DEVELOPMENT ASSESSMENT REPORT

Application No.	MOD/2023/0067
Address	40 Milton Street ASHFIELD
Proposal	Section 4.55(2) modification to approved boarding house including internal and external changes.
Date of Lodgement	14 March 2023
Applicant	Appwam Pty Ltd
Owner	Appwam Pty Ltd
Number of Submissions	Total: Eight (Initial Notification: One; After Renotification: Seven)
Value of works	\$6,311,441.00
Reason for determination at Planning Panel	Section 4.6 variation exceeds 10%
Main Issues	Non-compliance with maximum building height and FSR
Recommendation	Approved with Modified Conditions
Attachment A	Recommended modified conditions of consent
Attachment B	Plans of proposed development
Attachment C	Original assessment report
Attachment D	Approved plans

Figure 3: Approved plans - Section 2

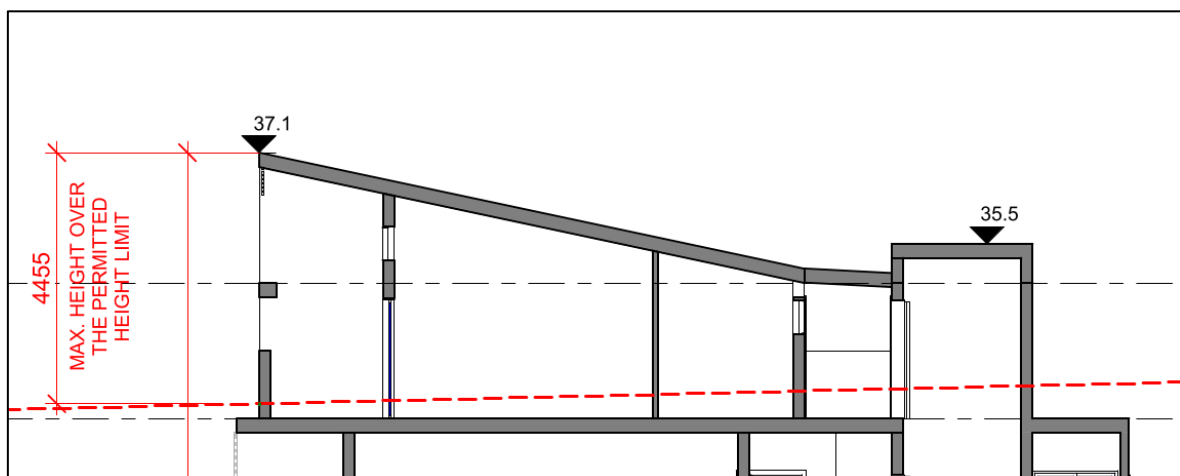
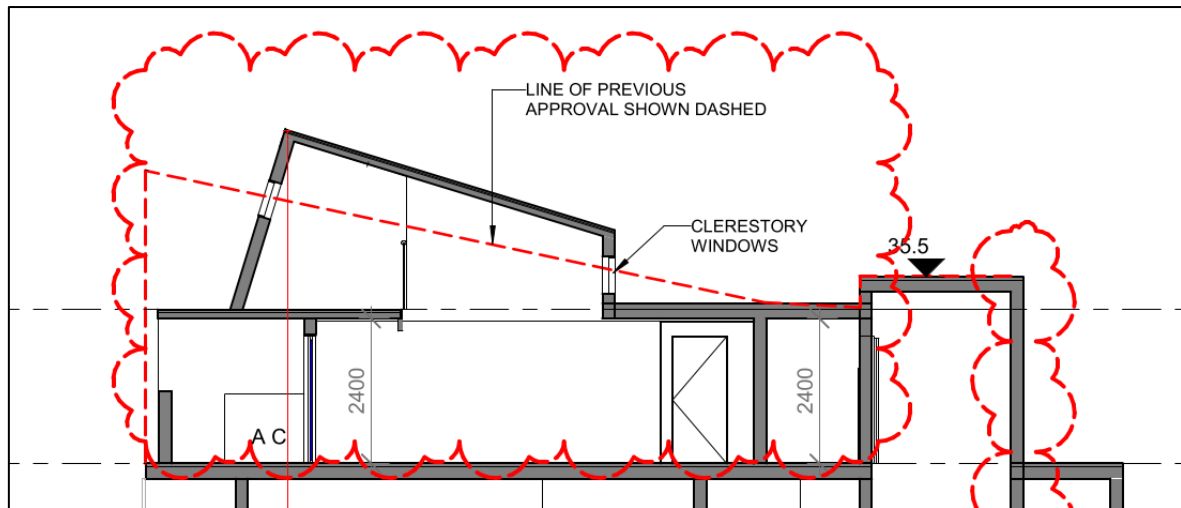
Approximately 90sqm of the additional FSR is a result of a change in roof form to accommodate an ‘up and over’ loft style room type to level 4 as illustrated in figure 3 and 4.

As outlined in the table above, the proposal results in a further variation to the height of building development standard under Section 4.3 of *IWLEP 2022* by 5.68m or 45.44%. The increase in height by 780mm is a result of a change in roof form to accommodate an 'up and over' loft style room type as illustrated earlier in figure 3 and 4.

Figure 5: Approved plans – level 1, 2, 3

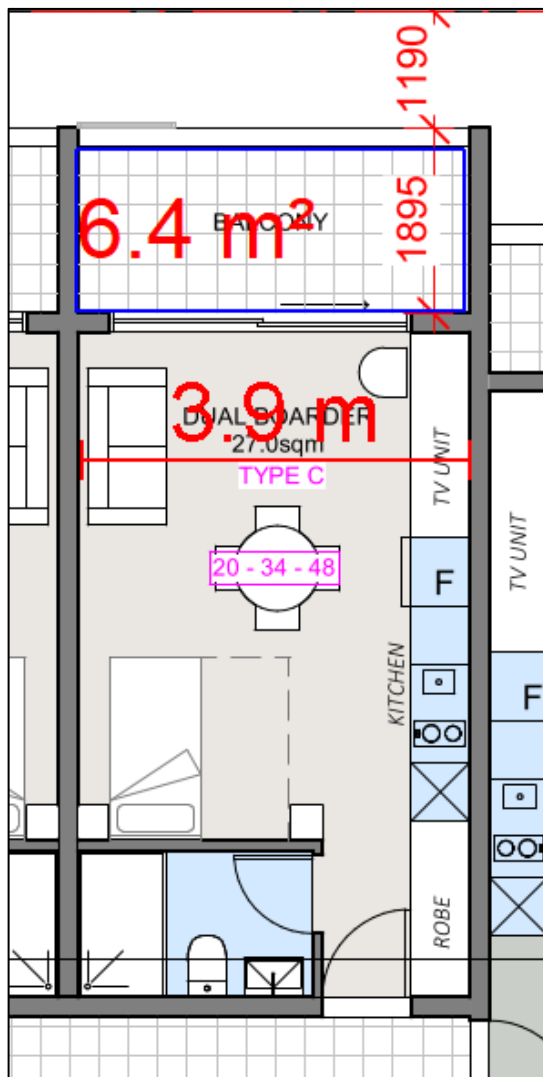
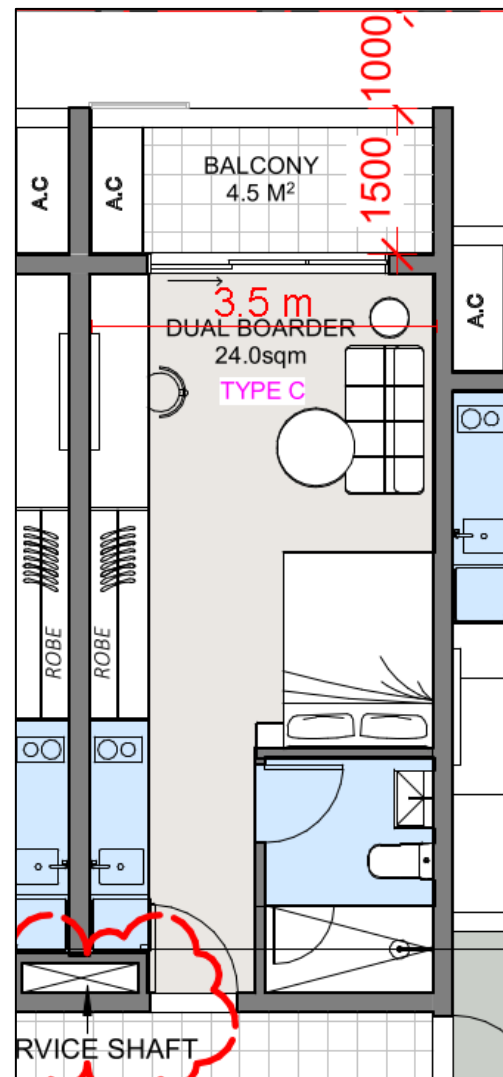
Approximately 50sqm is a result of reduced balcony sizes and depths to room type C across levels 1, 2, 3.

Figure 7: SRV dimensions of the vehicle proposed to service the site provided by the applicant

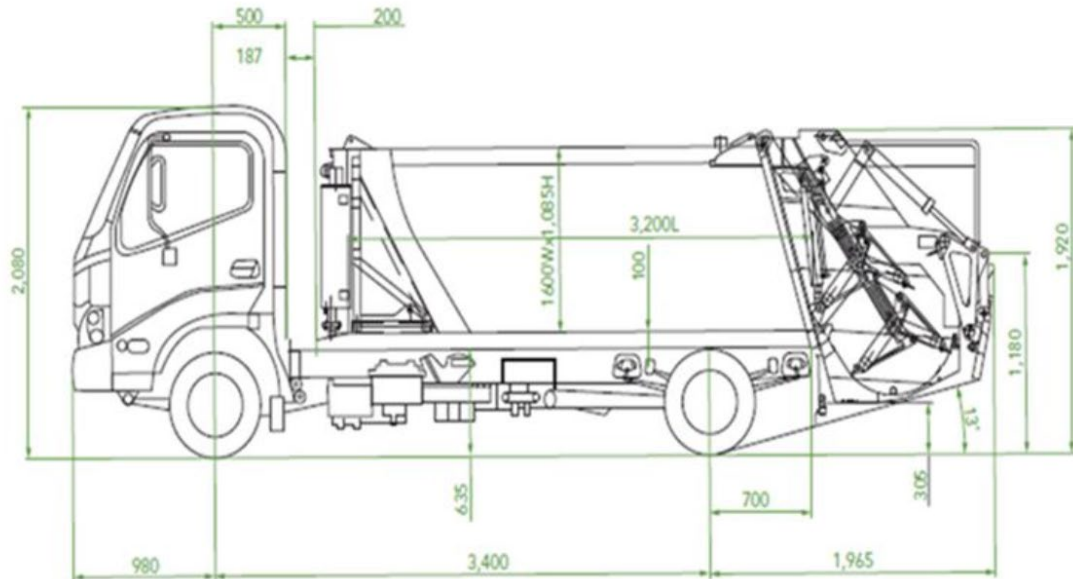
Regarding condition 22 e., the minimum clearance height of 2500mm above the accessible parking spaces is recommended to remain on the consent for unloading a roof mounted wheelchair hoist. This is consistent with AS/NZS 2890.6-2009.

The revised proposal has demonstrated that a private waste and recycling collection contractor can service the subject site on a twice weekly basis. The vehicle proposed for waste collection has a length of 6,345mm (refer to figure 7). It is noted that condition 24 prescribes a maximum length rather than a minimum length. The maximum length aligns with the dimensions of an SRV and as such should remain on the consent.

- Waste collection vehicles shall be limited to SRV trucks of Australian Standard maximum length of 6.4m *and a maximum height of 2.1m*. ~~The applicant must provide information to the satisfaction of Council on location the vehicle will stand for the collection of waste, clear of 'No Stopping' restrictions required at the corners of Milton Lane (prohibiting the standing of any vehicles at the corner). In addition, all waste bins must be planned and moved directly onto the waste vehicle and moved back on site. No bins shall be placed on the footpath awaiting collection or movement back on site. In addition, swept paths shall be provided for a small waste collection vehicle turning into Milton Lane from Norton Street on a street aerial view to confirm access.~~

Figure 8: Proposed modified driveway detail (dwg C122)

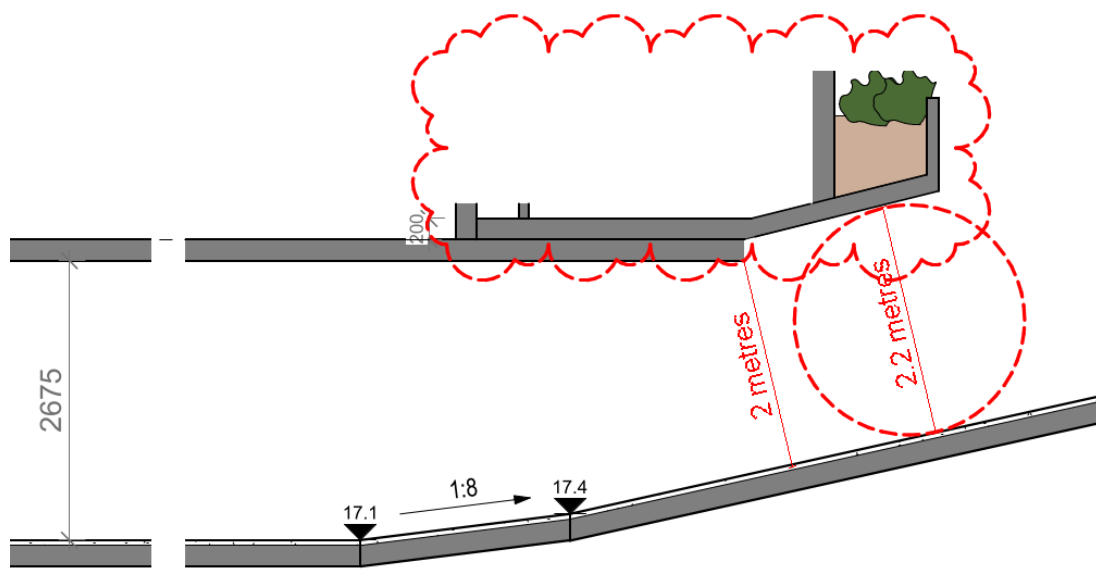
<p>The application seeks to amend condition 22 Parking Facilities – Major (including basement) to replace references to 2500mm with 2200mm (contained in c. and e.).</p> <p>Regarding condition 22 c., it is noted that the CIWDGP 2016 requires minimum floor to ceiling clearance height of 2500mm, which is to allow for a maximum vehicle height of 2200mm with 300mm clearance for building servicing. In addition, the proposed SRV to service the waste area within the basement has a minimum dimension of 2080mm (refer to figure 7). As such, the minimum clearance Council could recommend is 2400mm. As such, the driveway long section detail will need to be amended accordingly.</p>

- c. The plans must be amended and accepted by Council to identify a service vehicle facility within site with minimum dimension for a B99 vehicle such as a large transit van. Swept paths must be submitted demonstrating forward entry and exit. In addition longitudinal sections must be provided along both sides of the vehicular access ramp(s) and throughout the path of travel for a B99 utilising the loading bay to demonstrate that a minimum headroom of **2500 2400mm** is provided;

Figure 9: Floor plan of northern-most apartments at no. 44-48 Milton Street.

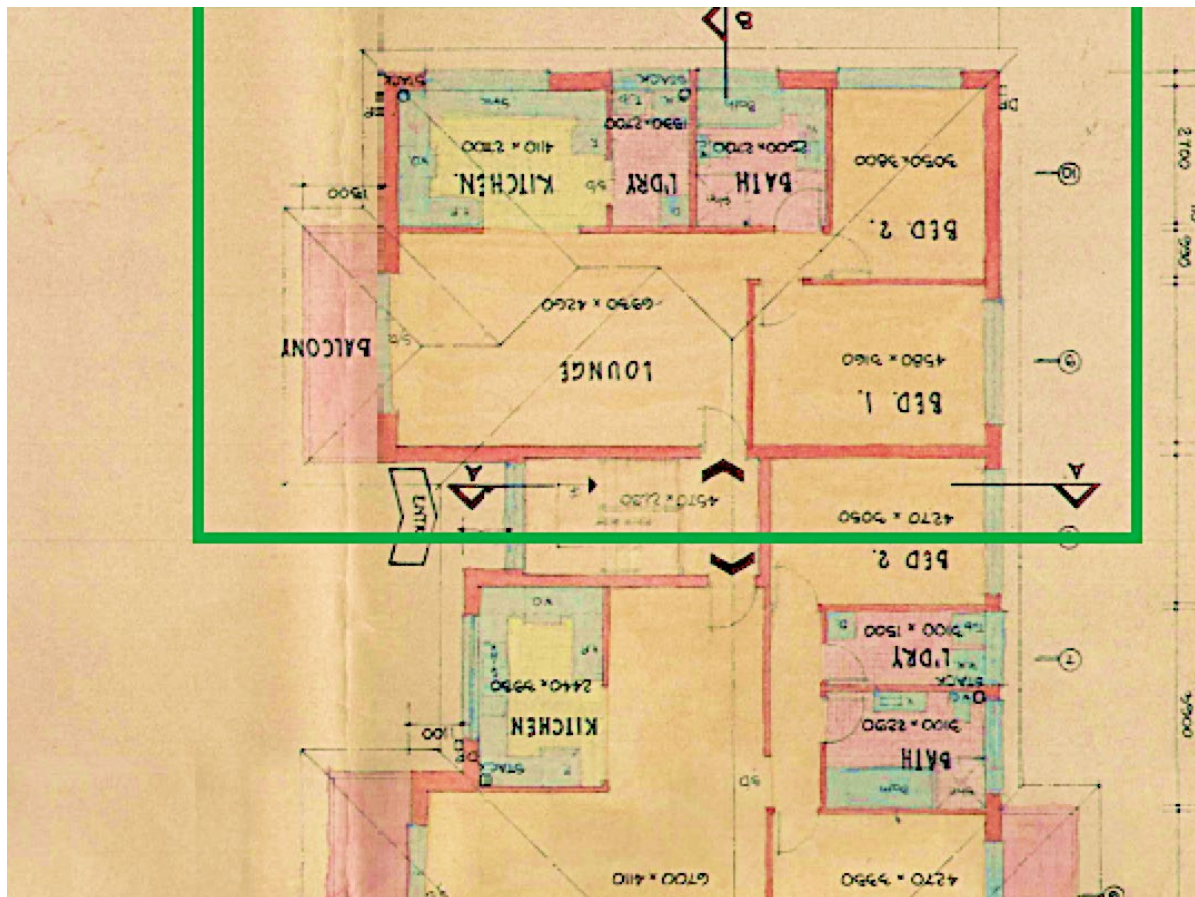
The proposed increase in height and change in building envelope results in a minor additional amount of overshadowing to no 44-48 Milton Street.

Shadow diagrams were submitted indicating the following as a result of the modified proposal:

- There is no change to the solar access outcomes of the ground floor and third floor apartments.
- Additional overshadowing is cast to the level two apartment as follows;
 - Additional shadowing is cast to the north facing bedroom window between 11am and 1pm,
 - Additional shadowing cast to the north facing kitchen window at 2pm,
 - Additional shadowing cast to the west facing living room and balcony at 2pm.
 - Two hours of direct solar access to the living area and balcony is maintained between 12.00pm-2.00pm on June 21st.
